Planning Commission Report

Application No. 2022-003

Location: 2500 County Road 10 and 5900 Shingle Creek Parkway

Requests: Preliminary and Final Plat, Zoning Code Amendment to Remove Subject Property from Central Commerce Overlay District, Rezoning and Establishment of a Planned Unit Development, and Site and Building Plan Approvals (4)

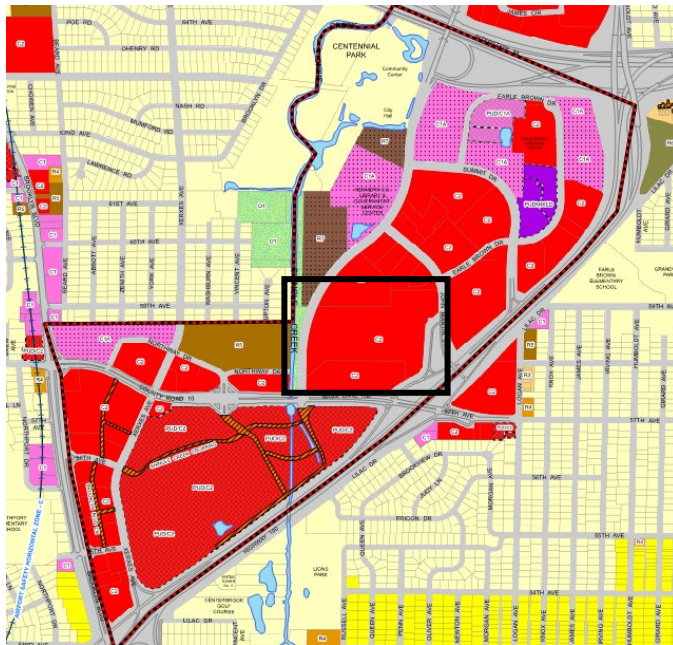
Further review is recommended for the lot line located between Lots 1 and 2, Block 4, as portions of proposed building (Site 4) courtyard and other site features appear to encroach across the proposed lot line, and the Applicant will need to consider access easement provisions with regard to the proposed structured parking between Sites 4 and 5, which will straddle the proposed lot line. Additional comments addressed inquiries on the anticipated ownership model and necessity of further separation for Lot 1, Block 1 (Site 1) as this area is contemplated for construction of an approximately 278-unit multi-family residential building (Site 1A), entrepreneurial market (Site 1B), and common plaza and amenity space. As Site 1B is still underway in its design and community engagement process, separate site and building approvals are required prior to any construction, and City staff will know at that point whether approval of a separate vertical subdivision/Registered Land Survey (RLS) or Common Interest Community (CIC) plat is the path for separating the Site 1 uses and ownership.

Other minor corrections on the proposed graphics and dedication pages are noted in the referenced memo from Webb Surveying, dated June 28, 2022.

Per preliminary comments provided to the City by Hennepin County on July 5, 2022, comments were outlined addressing the dedication of certain right-of-way (e.g. sidewalks, clear view triangle), and a recommendation to add curb work at the northeast intersection of Bass Lake Road (County Road 10) and Shingle Creek Parkway, which would extend the sidewalk space by tightening the roadway radii to slow right-turning vehicles as they cross through the intersection. Any final plat comments or requirements will have to be addressed as a condition of approval prior to any recording with Hennepin County.

Image 6. Example of Public Art Application as Class I Material (Site 3).

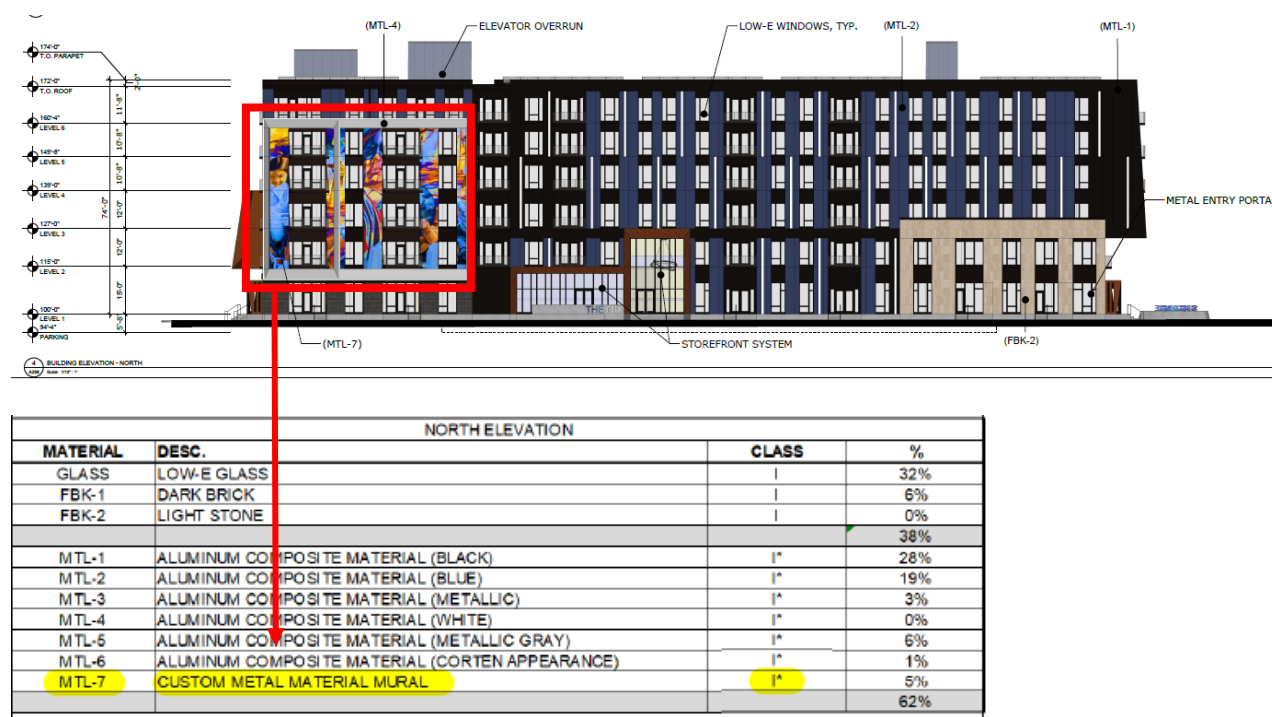
In earlier conversations with the Applicant and Applicant Architect, it was determined that at least two of the proposed multi-family buildings (namely Sites 1 and 3) had set aside sections of wall space for the integration of public art and had earmarked it as a "Class II" material. It was through these conversations that City staff determined that public art, as determined through selection of an artist for originally-commissioned work, as opposed to the application of commercially available graphics, could request consideration for Class I determination. The submitted plans appear to now identify these areas as "Class I." Refer to Image 6 below.

While some sets reflect breakdowns of both Class I and Class II materials (i.e. Sites 2 and 4), other sets only reflect Class I materials (i.e. Sites 1A and 3). City staff requests that the Applicant revise the elevation-

Image 7. Phase I Overall Structured, Surface, and Street Parking at Main/Lower Levels.

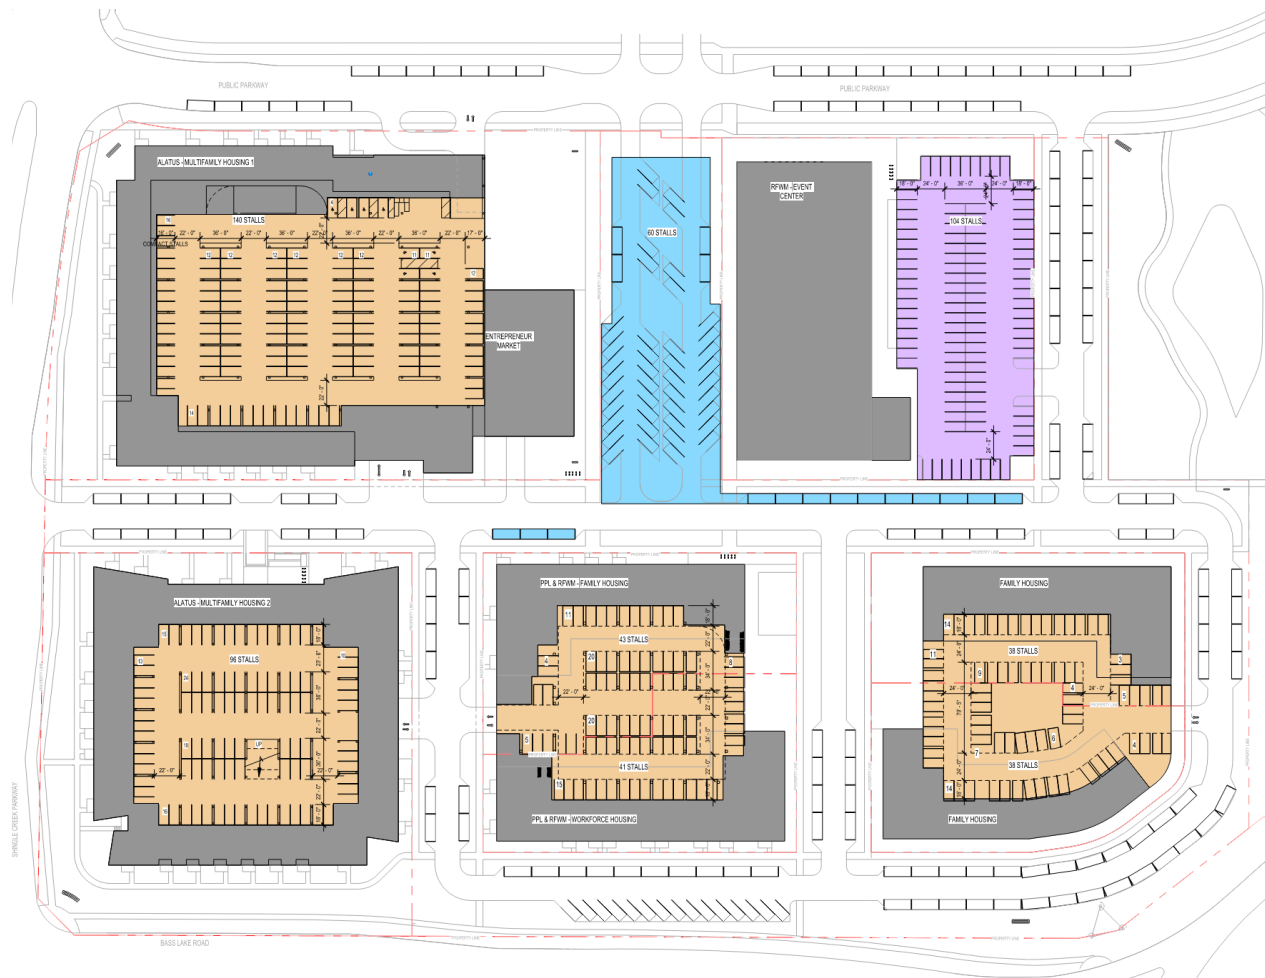
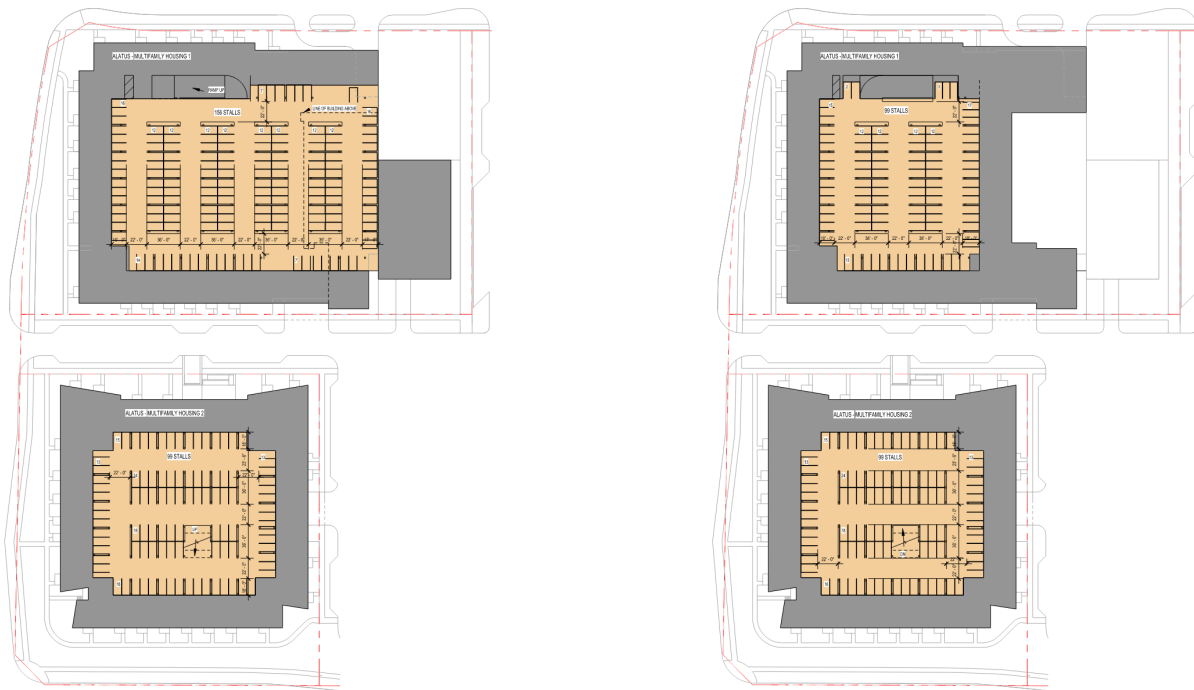
City staff further reviewed the outlined the proposed on-street parking, structured parking, drive aisles and widths with respect to existing City Code requirements. In reviewing the on-street parking, the drive aisles appear to meet the minimum requirements with respect to Fire Code and specifically fire access roads. City staff requests that the dimensions provided along the eastern portion of the Phase I development be revised to address overlap between the indicated drive aisle widths and proposed parallel (0 degree) parking. The Applicant shall work with City Fire and Building to address potential revisions to the outlined community flex street and turning radius requirements for the proposed private streets.

The parallel on-street parking (private) meets the minimum dimensional requirements outlined under Section 35-702 (*Parking Space Standards*) of 8-feet in width by 24-feet in length, although the drive aisles are reduced assuming two-way traffic. Similarly, the angled parking indicated along the proposed community flex street appears to meet minimum dimensional standards, although plan sets should denote the angle of parking. For the Site 2 surface lot, the minimum two-way drive aisle requirement of 24-feet in width is met, as well as the minimum parking space dimensional standards for perpendicular 90-degree parking of 8.6-feet in width by 18-feet in length.

The structured parking contemplated for the multi-family residential buildings contemplates the provision of select compact parking along the outer perimeters of the parking garage with a reduced space depth of between 16 and 17-feet, and drive aisle widths of 22-feet. The parking plans should be revised to reflect minimum dimensions for proposed ADA parking and loading spaces, as the typical standards presented in the submittal indicate 9-foot widths and 5-foot loading stalls, and the circulation of traffic within the garage (e.g. one-way vs. two-way).

Image 9. Proposed connections within Phase I Opportunity Site to existing trails and sidewalks.

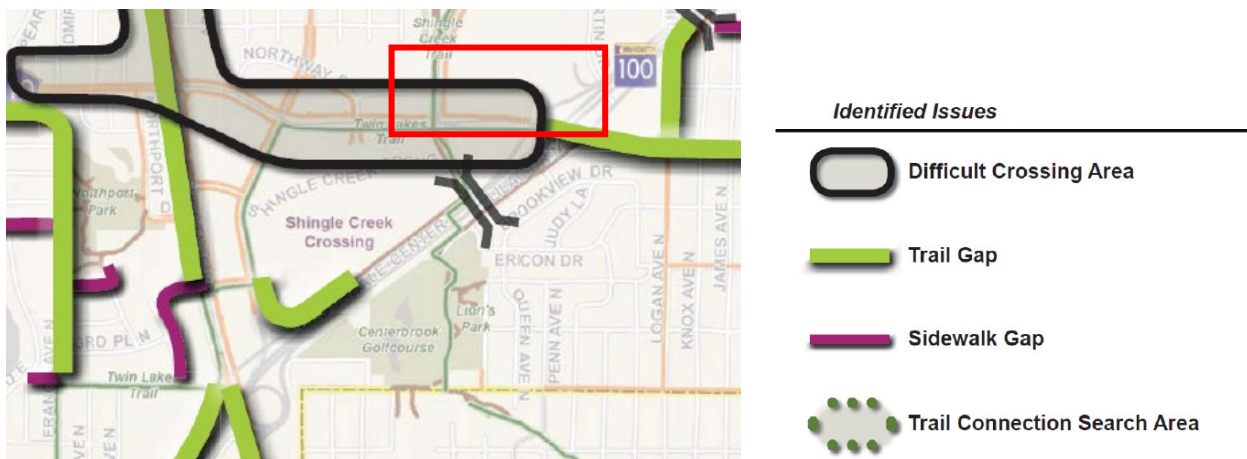
Per City Code, bicycle and pedestrian facilities shall be constructed and connected to existing adjacent bicycle and pedestrian infrastructure, including the provision of bicycle parking. Following a review of the submittal, City staff requests that the Applicant provide a detailed exhibit noting all marked crosswalks and connections.

City staff recommends that the Applicant re-visit proposed pedestrian and trail connections to account for additional crosswalks and pathways for access to on-site amenities, existing nature trails, bike trails and sidewalks. Refer to Image 9 below. This will be of greater importance with the approximately 3.5-acre Three Rivers Park District park proposed just north of Site 1, as there will likely be re-alignments to existing regional trails to provide direct access to the park site. Refer also to Map 4 below, which outlines existing trail gaps under the 2014 Brooklyn Center Bicycle and Pedestrian Plan.

Image 10. Submitted Overall Photometric Plan with Proposed Lighting.

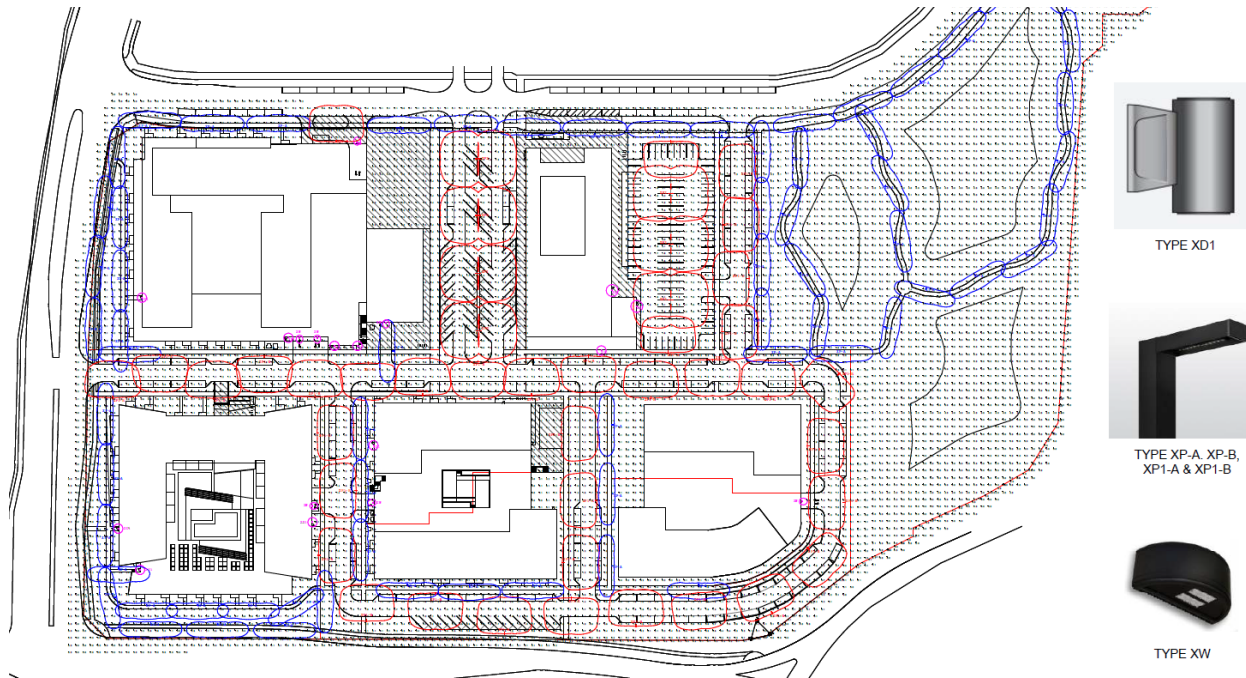
1. Revise overall PUD photometric plan to clearly note property lines on the overall PUD plans, and indicated on Sheet E015 (*Electrical Site Photometrics*). Minimum, maximum, and average foot-candles are presented in a table format and indicate maximum foot-candles at the property lines of between 0.01 to 2.8 foot-candles, which may require adjustment.

3. Provide individual (site) photometric plans as part of any sets submitted for permit review.
4. Coordinate with City staff for CPTED review, including incorporation of lighting that aligns with Illuminating Engineering Society (IES) standards for sidewalks, parking lots, parking ramps, etc. Uniformity in lighting throughout these areas should be considered as well as the use of wall packs or alternative methods at entrances or areas where sufficient lighting is difficult to achieve by way of a light pole.

Image 11. Submitted Plans for Outdoor Playground at 24-Hour Childcare Center (Site 2).

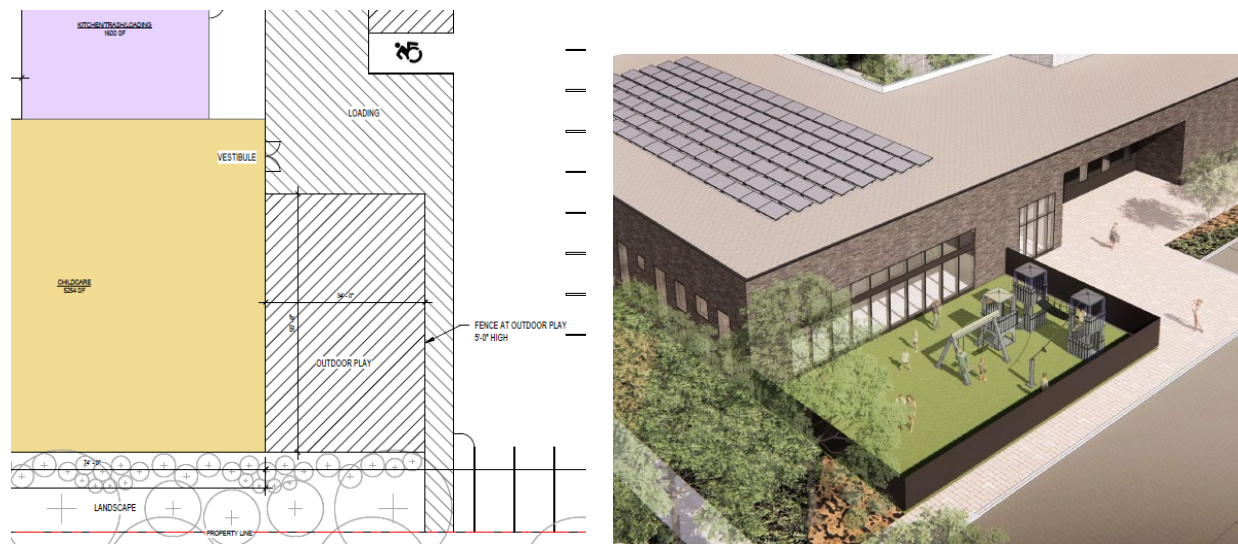
As proposed, the 24-hour childcare center (Site 2) indicates installation of an approximately 5-foot high fence. Per existing Zoning Code requirements, outside recreational facilities shall be appropriately separated from the parking and driving areas by a wood fence not less than four (4) feet in height, shall be contiguous to the daycare facility, and not located in any yard abutting a major thoroughfare, unless buffered appropriately. No more than half (50-percent) of the playground area shall be of impervious

surfacing, and shall be bounded on no more than two sides by parking and driving areas.

Image 12. Submitted Plans for Outdoor Playground at Sites 4 and 5 (Multi-Family Residential).

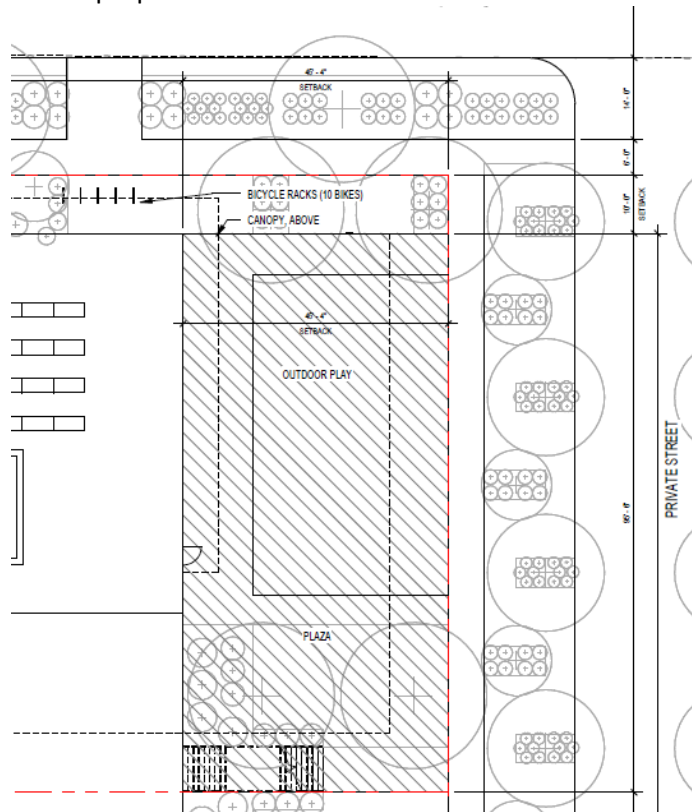
A second playground area is proposed for Sites 4 and 5, as outlined Image 12 below. As is indicated in the submittal plans, Site 4 proposes construction of a 60-unit multi-family residential building that would be catered to family-style units, with 75-percent of the units committed to units two-bedrooms and above. A second multi-family residential building (Site 5) to be constructed in the future, would ultimately share parking and select site improvements and amenities. The Applicant shall provide detailing that demonstrates fencing provisions given proximity to the street, as well as sidewalk connections to the playground from the building. It should be noted that an approximately 1,000-square foot interior play area is proposed for Site 4 as well.
